ADDENDUM NUMBER TWO

University Physician's Medical Building (UPMB) – 4th Floor – MOA
Clinic Renovation
MU Project No. #CP221944
At the University of Missouri
Columbia, MO
For the Curators of the University of Missouri

Addendum Dated: 27 October 2022

Project Number: 14110005

G200

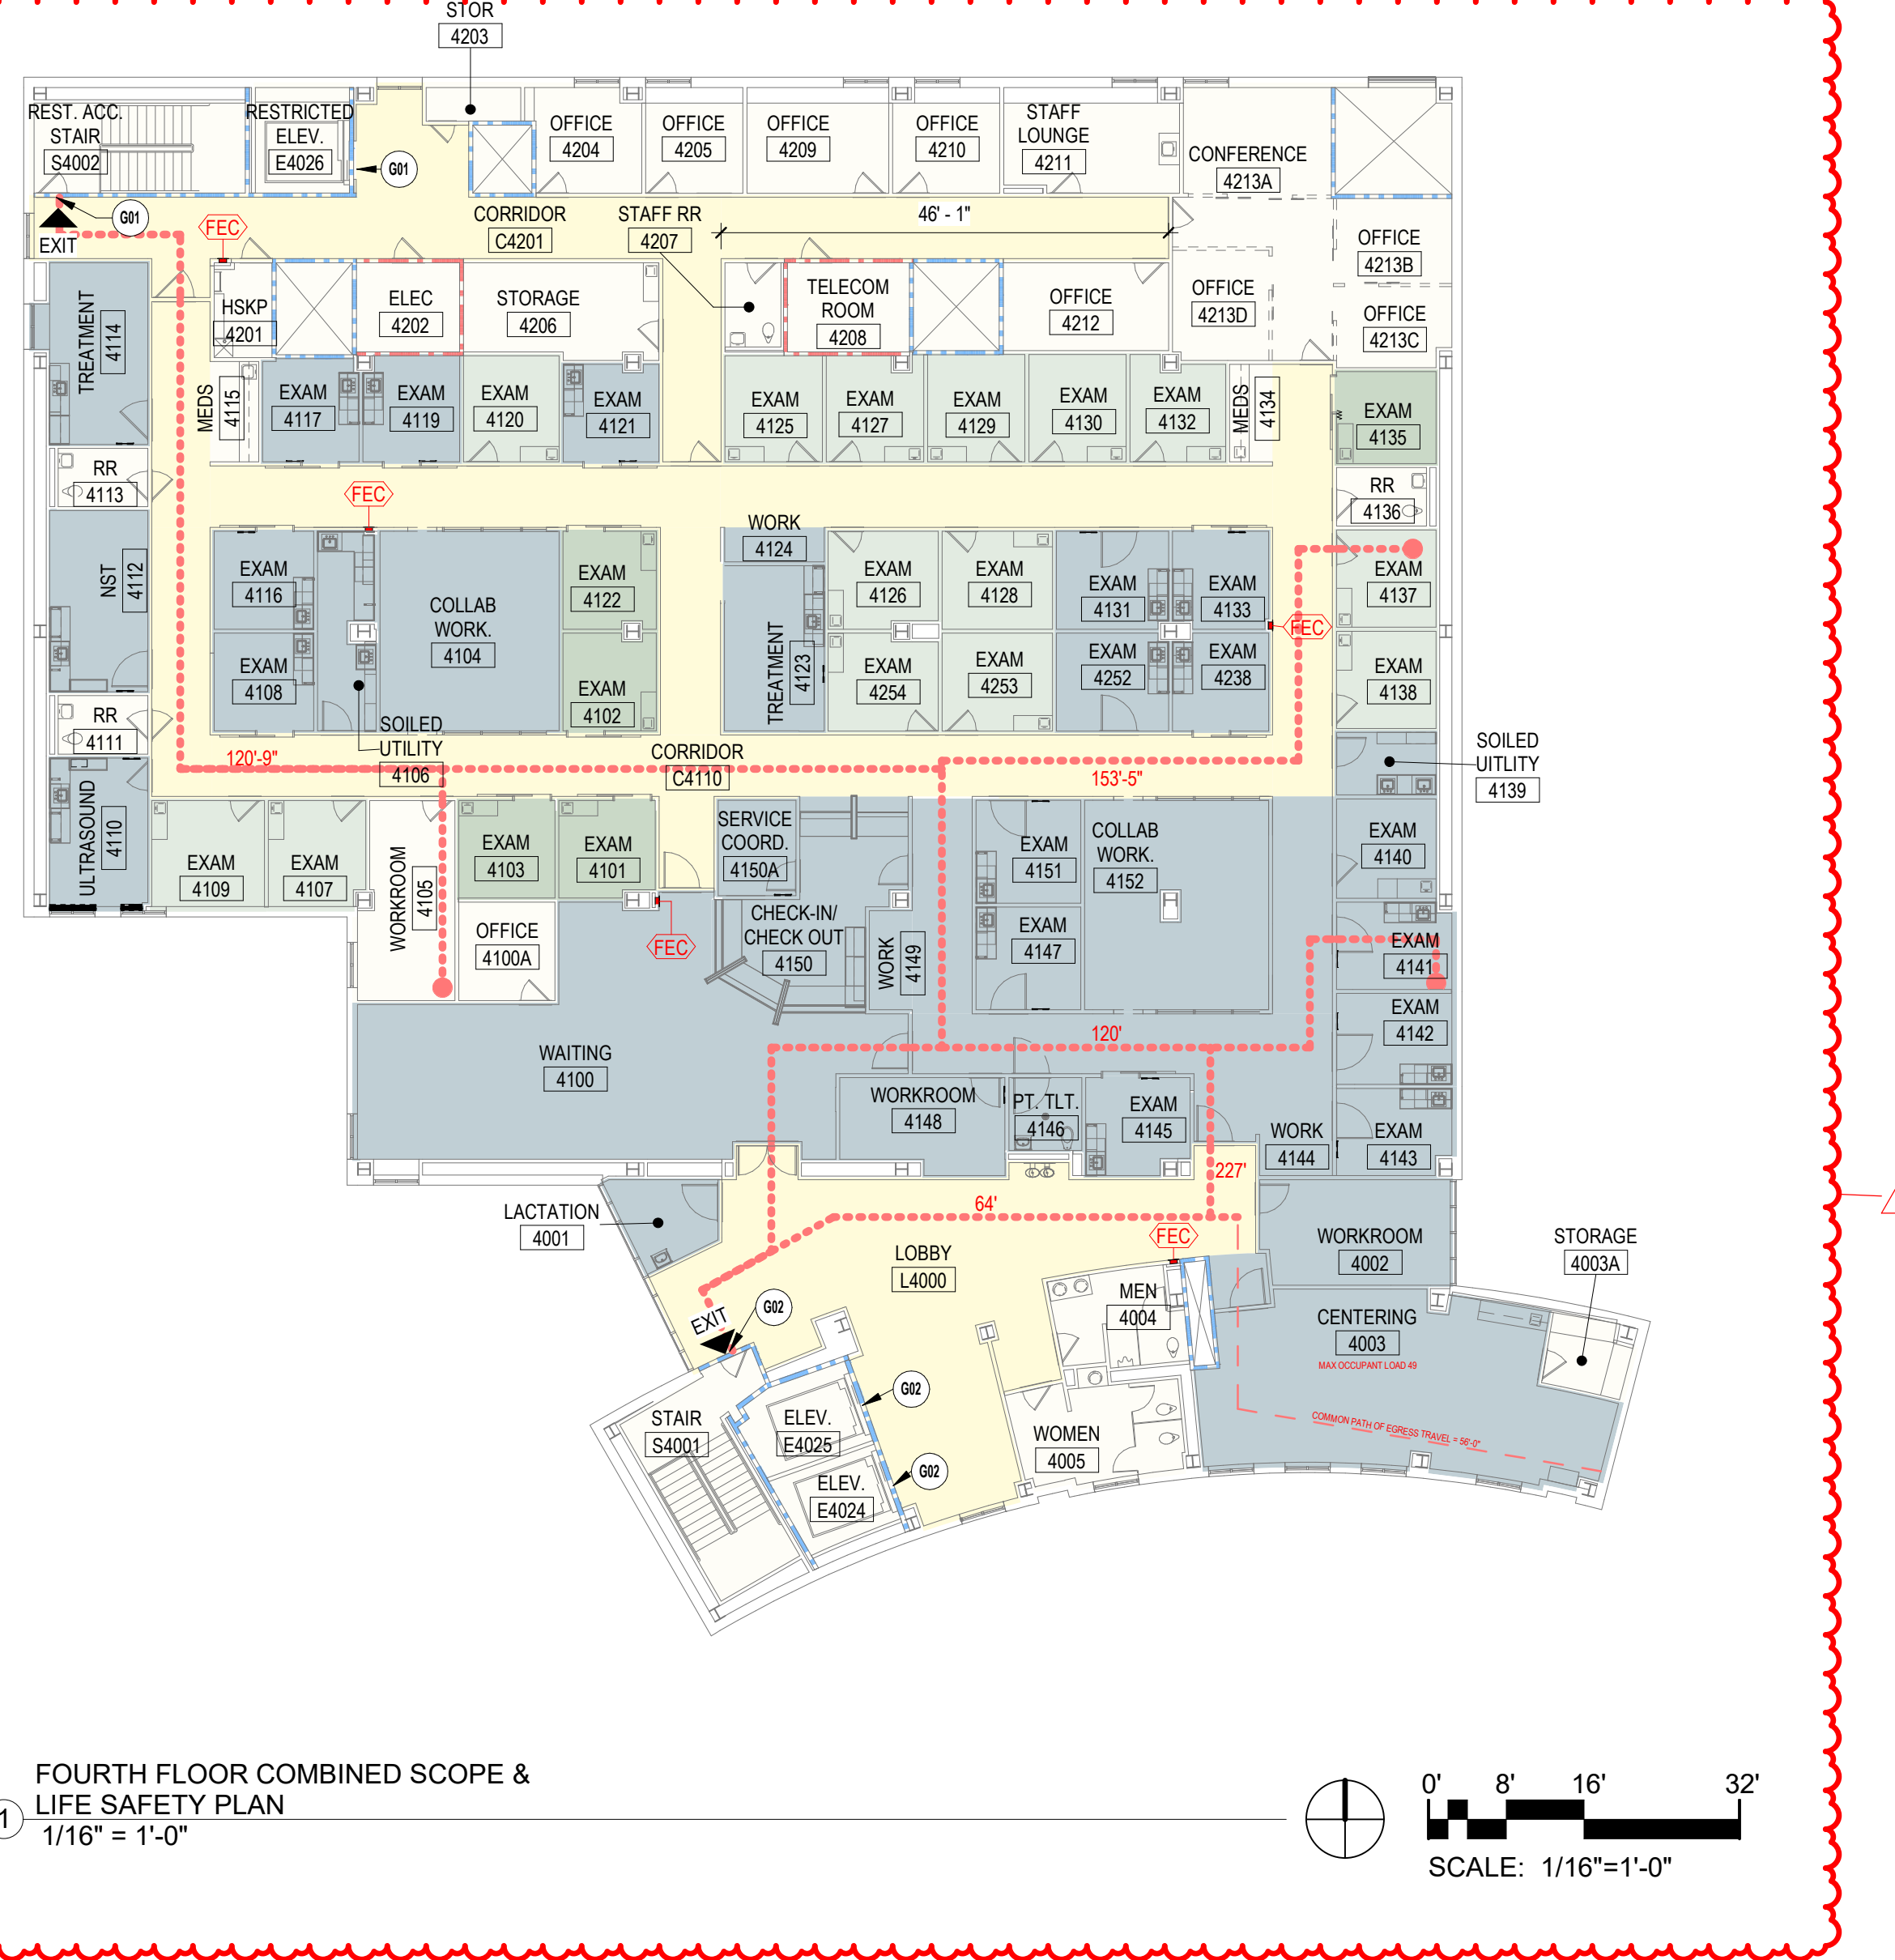
1. *Include Statement of Special Inspections on Construction Documents or state that none are required (2021 IBC 107.1 & 1704.3).*
 - a. None required. This is shown on sheet G200 Addendum #02.

2. *Include list of Deferred Submittals or state that none are anticipated (2021 IBC 107.3.4.1).*
 - b. Deferred Submittals will include Fire Alarm and Fire Sprinkler. This is shown on sheet G200 Addendum #02.

3. *Provide Risk Category for the building on the construction documents.*
 - c. Risk Category II. This is shown on sheet G200 Addendum #02.
4. *G200: Demonstrate compliance with 2021 IBC Section 703.5, Marking and Identification of fire rated wall assemblies.*

- a. All fire rated wall assemblies are existing to remain.
5. *G200: Document that Centering Room #4003 will have signage posted stating a max. occupant load of 49 posted inside the room. A posted occupant load of 49 for this space requires the approval of the AHJ.*

- b. Refer to attached letter from Charles D. Bouse, Jr. Dated 04/20/2022. Signage will be provided in this room per note A11 on sheet A124.
6. *G200: Document that Corridor #C4202, as called out on sheet A114, is a dead-end corridor less than 50'.*

- c. This is an existing corridor to remain, dimension is shown on sheet G200 Addendum #02.
7. *G200: Centering Room #4003 shows a common path of travel of 56'. Provide clarification of two exits being available where the common path of travel is shown to end.*

- d. This is shown on sheet G200 Addendum #02.
8. *G200: Document occupant loads of areas on plan to show how occupant load of 172 listed in Plumbing Fixture Count Table was derived.*

- e. This is shown on G200 Addendum #02.
9. *G200: Clarify Fire Resistance Fire Rating Requirements for Roof Construction. Table 601 shows Type IB roof construction having a 1-hour rating.*

- f. Previous drawings of building indicated this to utilize sub note b as 20' above the finish floor. Upon further review, Roof Construction has been updated on G200 Addendum #02.

1. DRAWING G200: CODE SUMMARY & LIFE SAFETY PLAN
 - a. REVISE drawing per GBA review (see above)
2. DRAWING A100: DEMOLITION PLAN- FOURTH FLOOR
 - a. ADD clarification to note X27.
3. DRAWING E101: ELECTRICAL FOURTH FLOOR NEW WORK PLAN
 - a. REVISE keyed note 3 to read: PROVIDE FINAL CONNECTION TO NEW BOTTLE/WATER COOLER, REUSE EXISTING CIRCUIT WIRING AND ADD A 20A GFCI RECEPTACLE FOR CONNECTION AT THE UNIT. COORDINAE THE LOCATION OF RECEPTACLE WITH BOTTLE/WATER COOLER SHOP DRAWING

A100

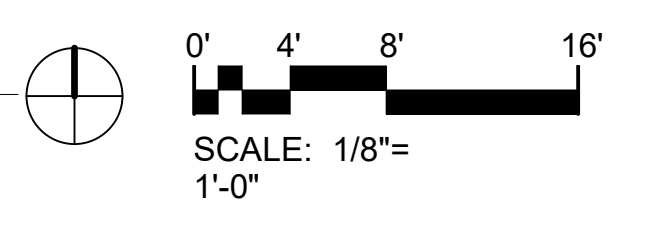
1. *Could we get clarification on Note X06 - Remove existing flooring and base entirely. It does not show this note, so where is this supposed to take place? Also could we make clear start and stop points of removal of resilient flooring in Note X26 and X27?*
 - a. Note X06 is located in Room 4206. Clarification has been provided on Notes X27. Note X26 applies to the entire room, demo stops at the middle of the doorway. See revisions on sheet A100.
